State of California
AIR RESOURCES BOARD

CALIFORNIA EVAPORATIVE EMISSION STANDARDS AND TEST PROCEDURES FOR 2001 AND SUBSEQUENT MODEL MOTOR VEHICLES

Adopted: August 5, 1999
Amended: June 22, 2006
Amended: October 17, 2007
Amended: [insert amended date]

Note: Proposed amendments to this document are shown in underline to indicate additions and ~~strikeouts~~ to indicate deletions compared to the test procedures as last amended October 17, 2007. Existing intervening text that is not amended is indicated by a row of asterisks (* * * *).

Figure 2: Test Procedure for 2001 and Subsequent Model Motor Vehicles

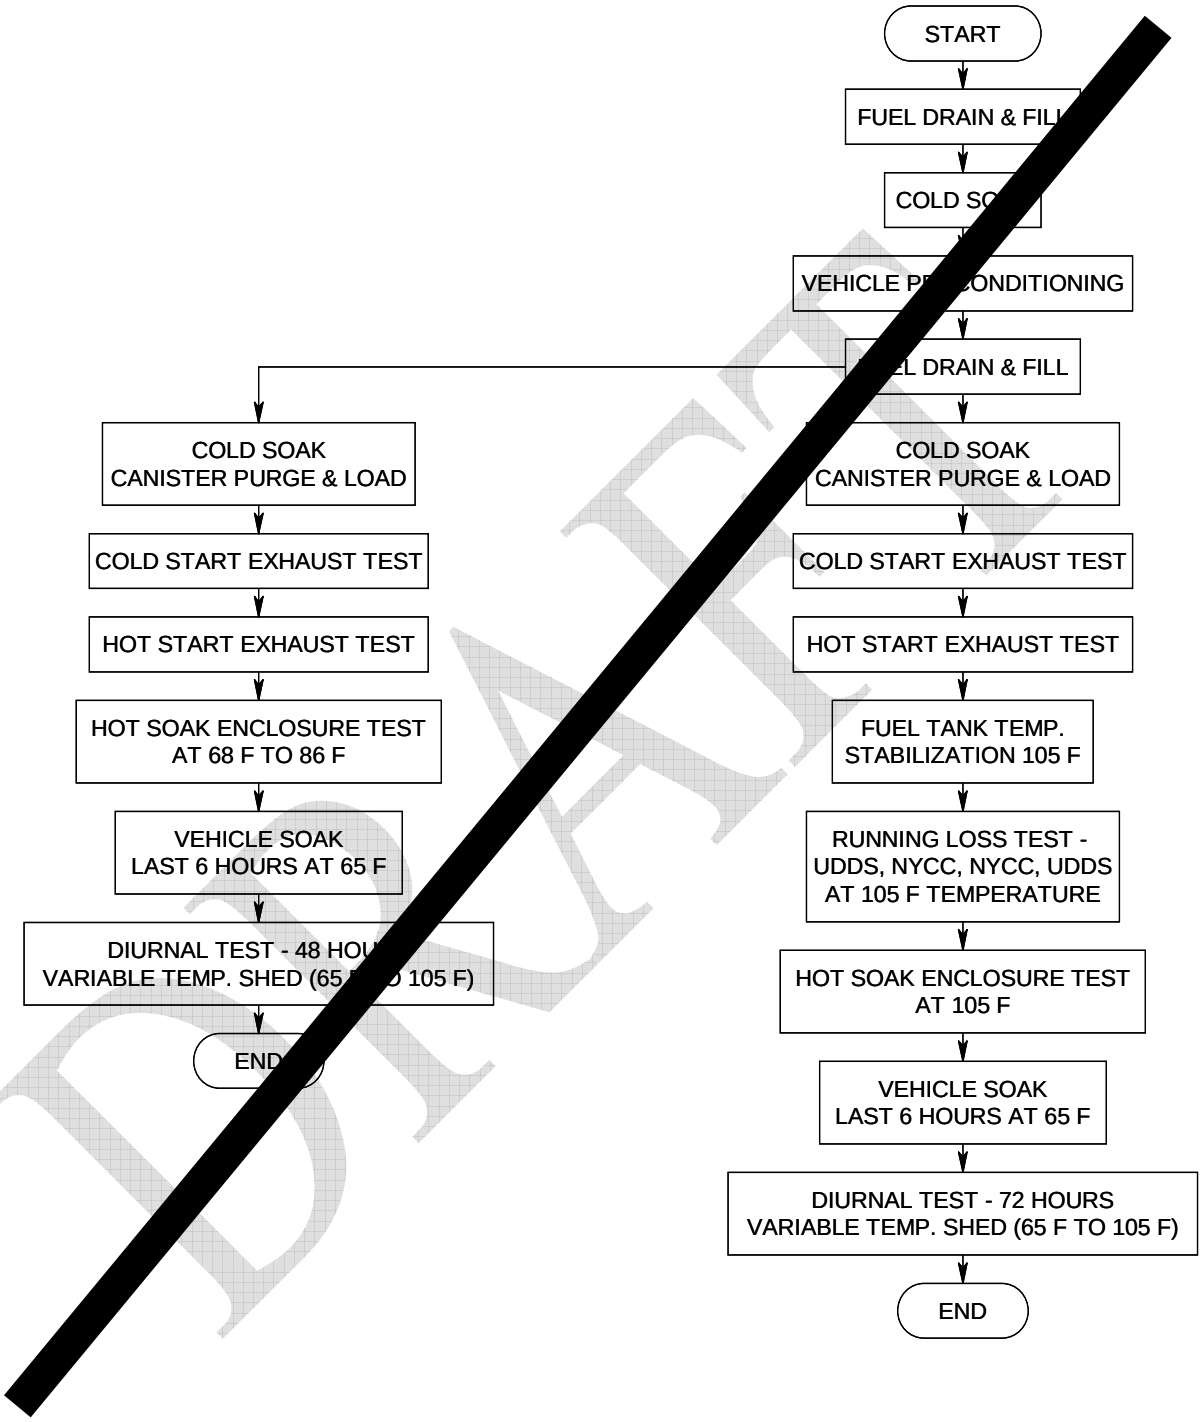
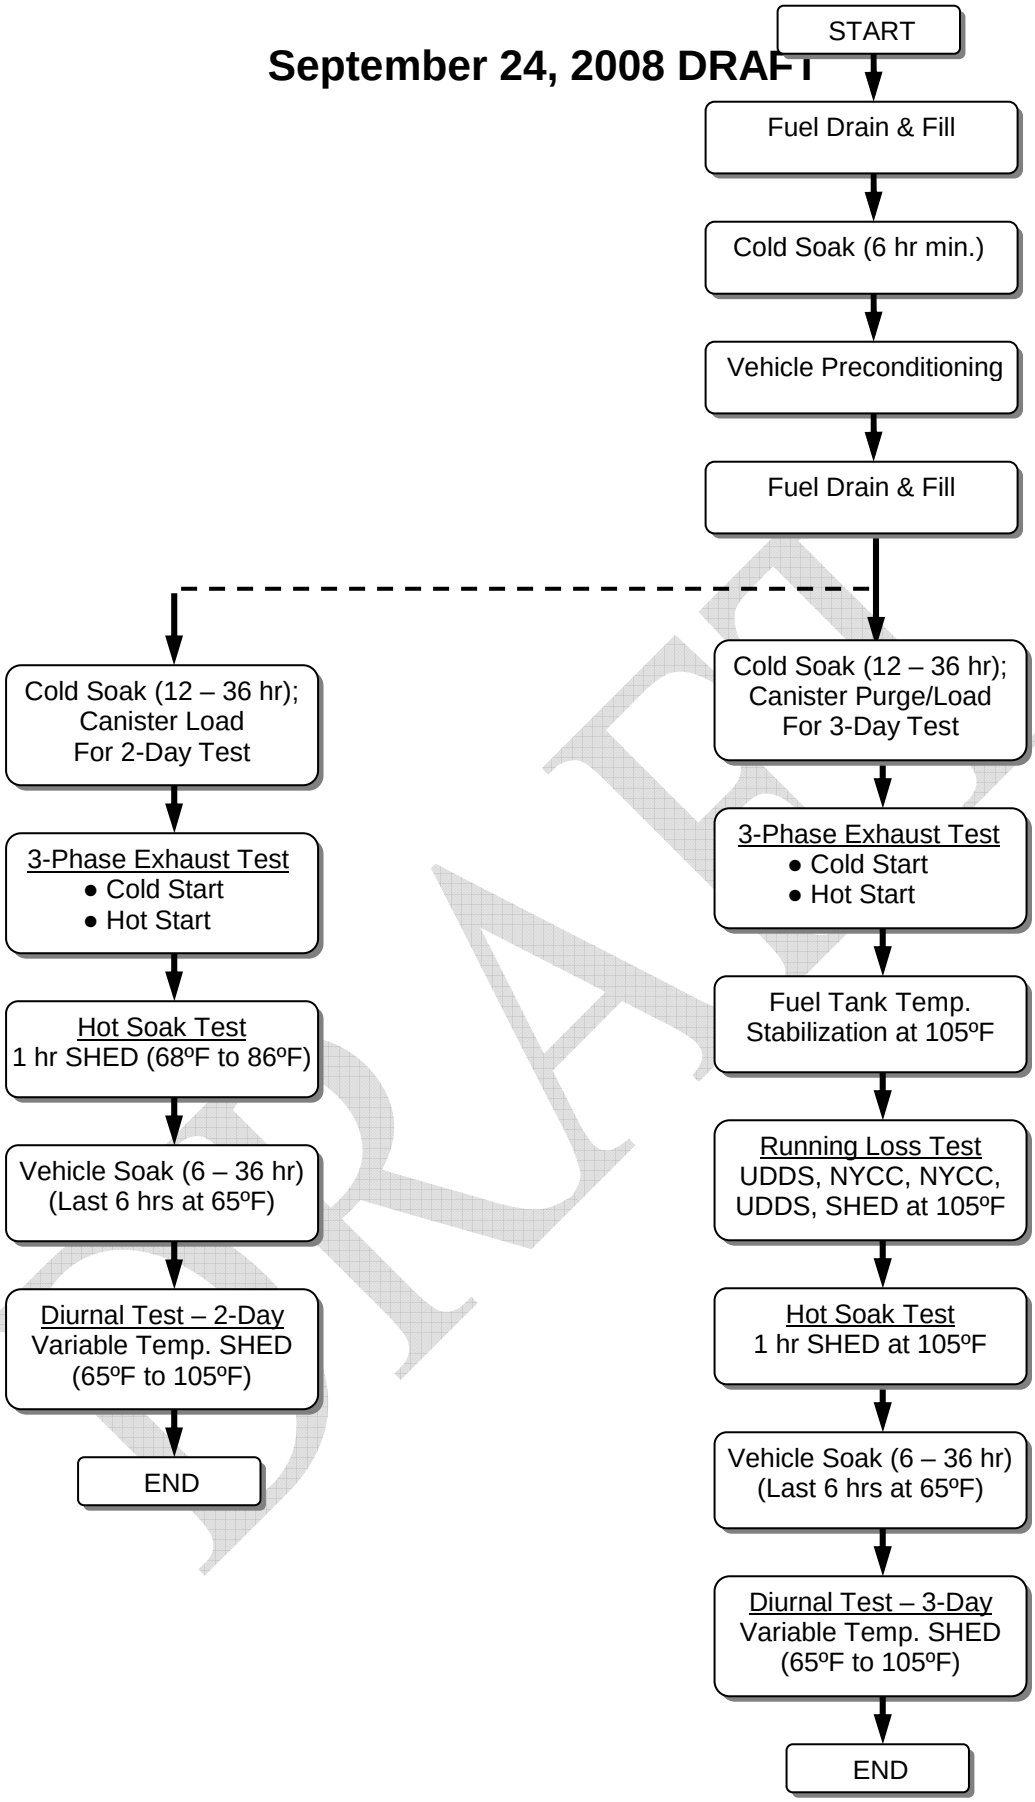
1.1. The test sequence shown in Figure 2 (Figure 3A or 3B for hybrid electric vehicles) describes the steps encountered as the vehicle undergoes the three-day diurnal sequence and the supplemental two-day diurnal sequence to determine conformity with the standards set forth. Methanol measurements may be omitted when methanol-fueled vehicles will not be tested in the evaporative enclosure. Ambient temperature levels encountered by the test vehicle throughout the entire duration of this test sequence shall not be less than 68^oF nor more than 86^oF, unless otherwise specified. The temperatures monitored during testing shall be representative of those experienced by the test vehicle. The test vehicle shall be approximately level during all phases of the test sequence to prevent abnormal fuel distribution. The temperature tolerance of a soak period may be waived for up to 10 minutes to allow purging of the enclosure or transporting the vehicle into the enclosure.

1.3. The three-day diurnal test sequence shown in Figure 2 (and Figure 3A or 3B for hybrid electric vehicles) is briefly described as follows:

1.18. The supplemental two-day diurnal sequence in Figure 2 (and Figure 3A or 3B for hybrid electric vehicles) shall be conducted according to sections III.D.1.4. through III.D.1.17., with the following exceptions:~~the steps described in 1.1~~

Figure 3A: Test Procedure for 2001 and Subsequent Model Hybrid Electric Vehicles

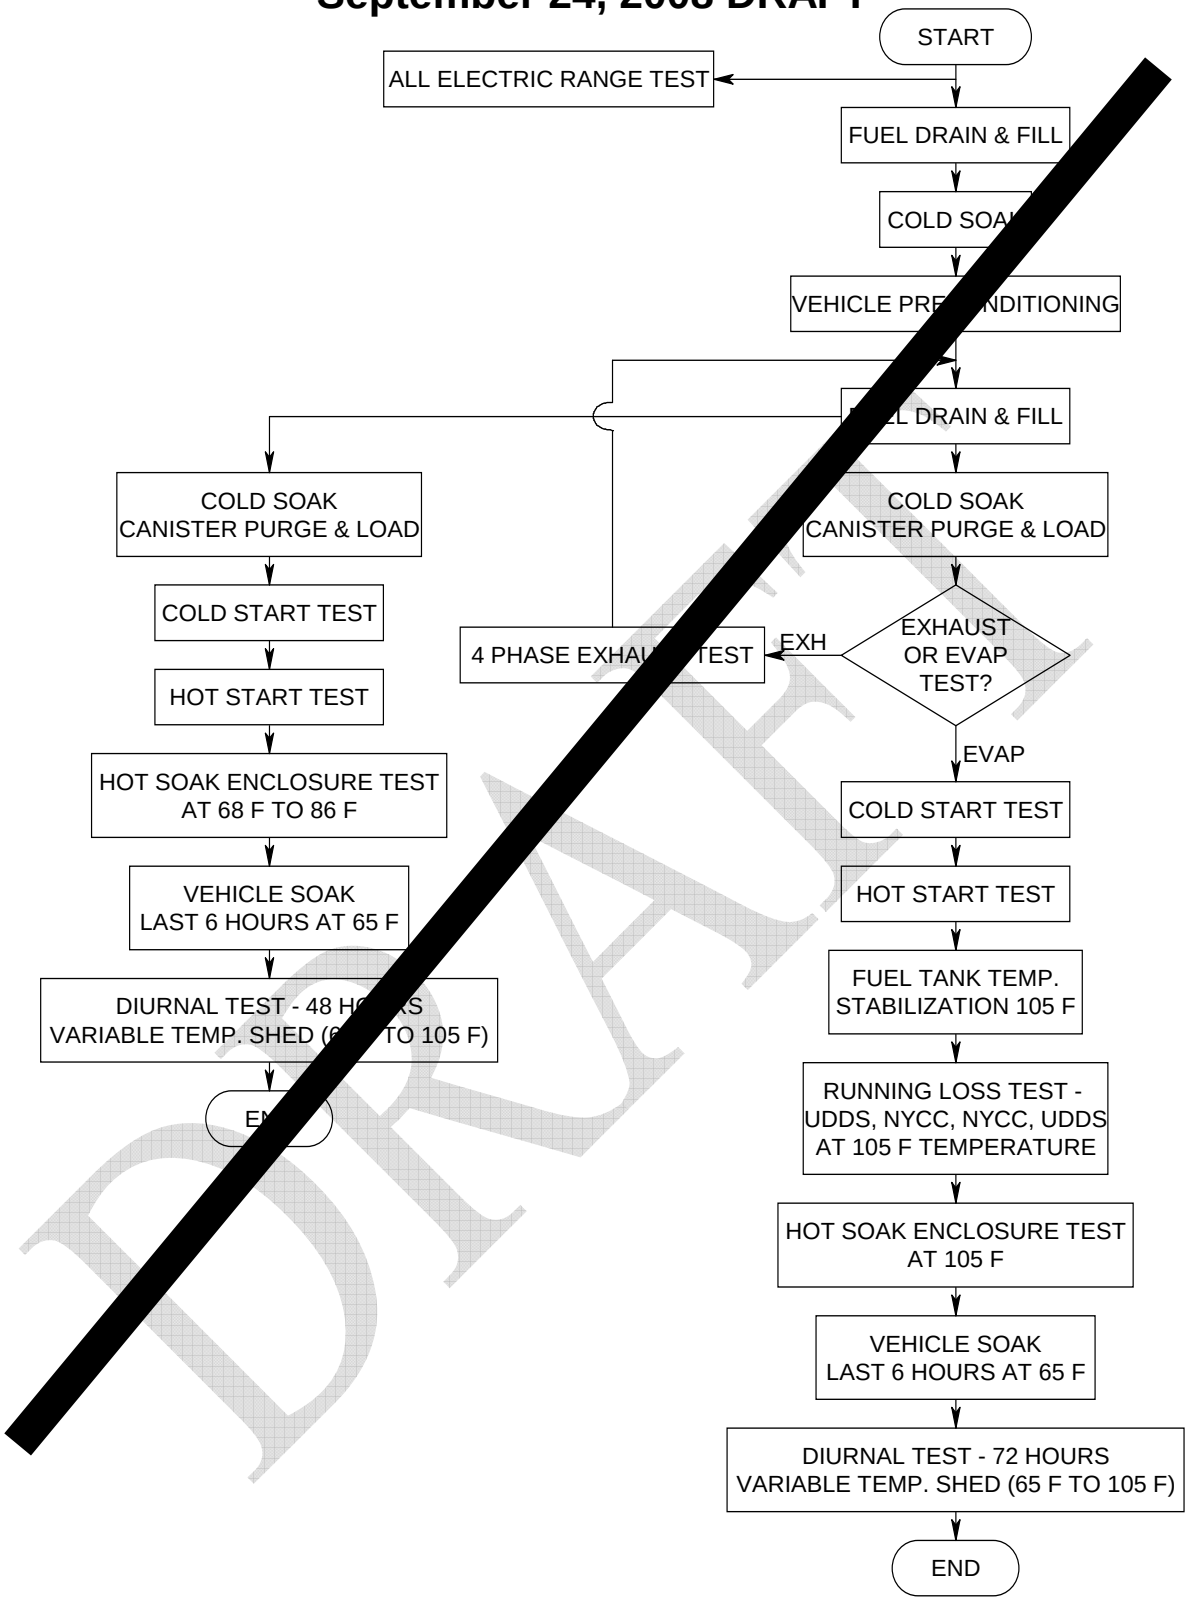
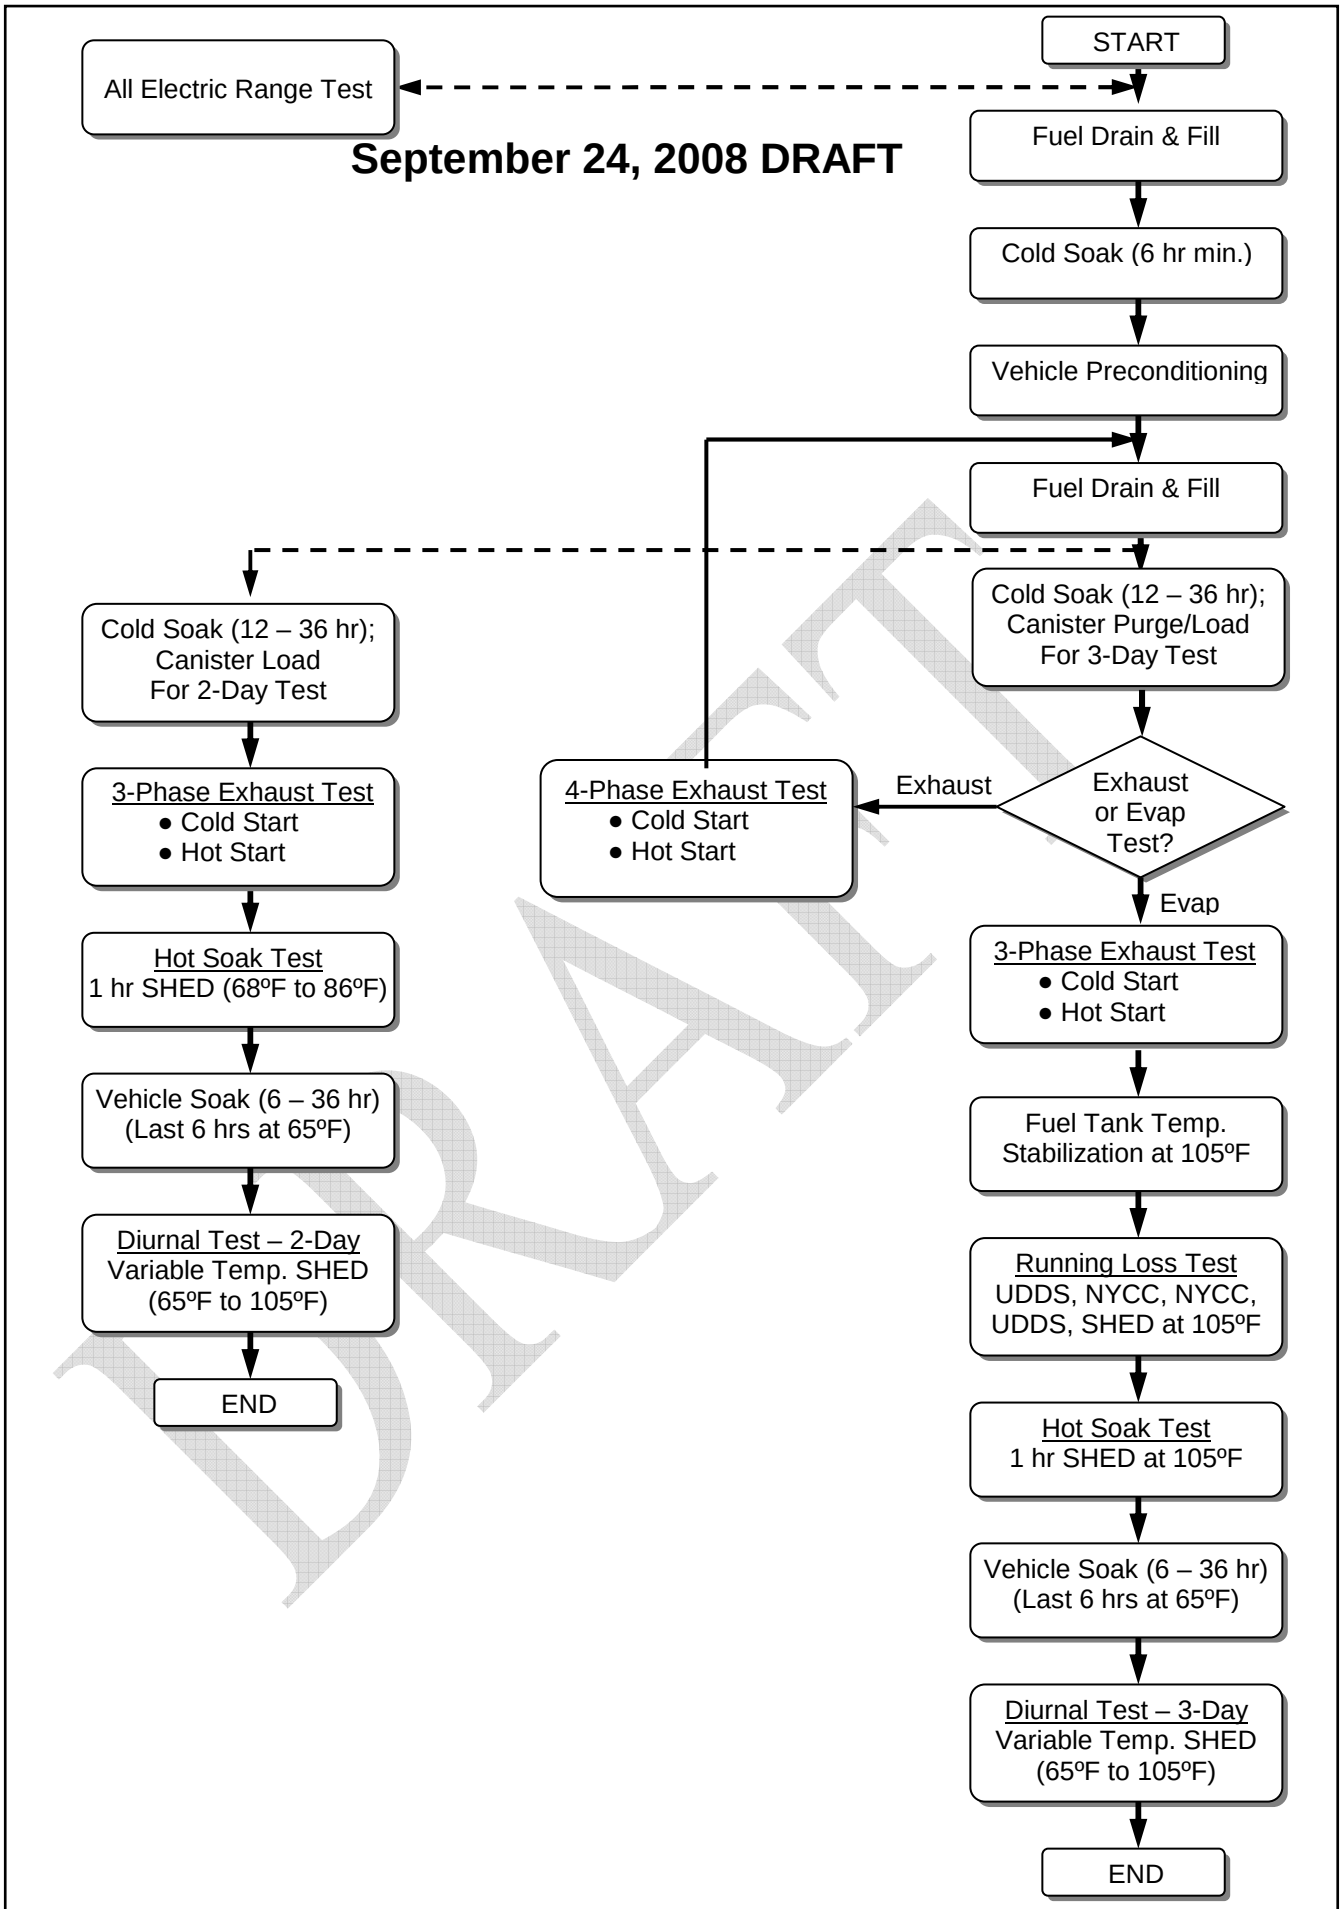
~~1.7.1.~~1.12. For 2001 through 2010 model-year hybrid electric vehicles, a four-phase exhaust test shall be performed as shown in Figure 3A pursuant to the

1.12.2. When a four-phase exhaust test is performed with the evaporative emission test sequence as shown in Figure 3A, the evaporative emission test sequence shall begin, at section III.D.1.6., after the four-phase exhaust test is completed. The ensuing standard three-phase exhaust test shall then be performed without exhaust emission sampling.

1.18.7. Emission sampling is not required for the standard three-phase exhaust test performed in the supplemental two-day diurnal test sequence shown in Figure 3A.
